CK-2369

SPUZZUM 24000 2.3km

2019 Inspection

Downstream from Crossing

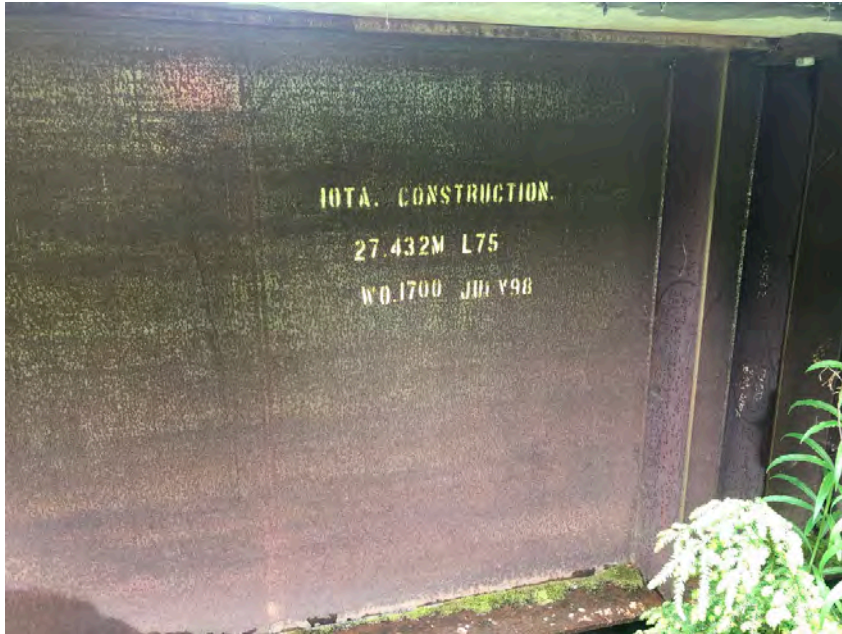
More damage to deck panels and ballast wall

| 2 | Medium | Repair damage to deck panels and both ballast walls and add material to both approaches |
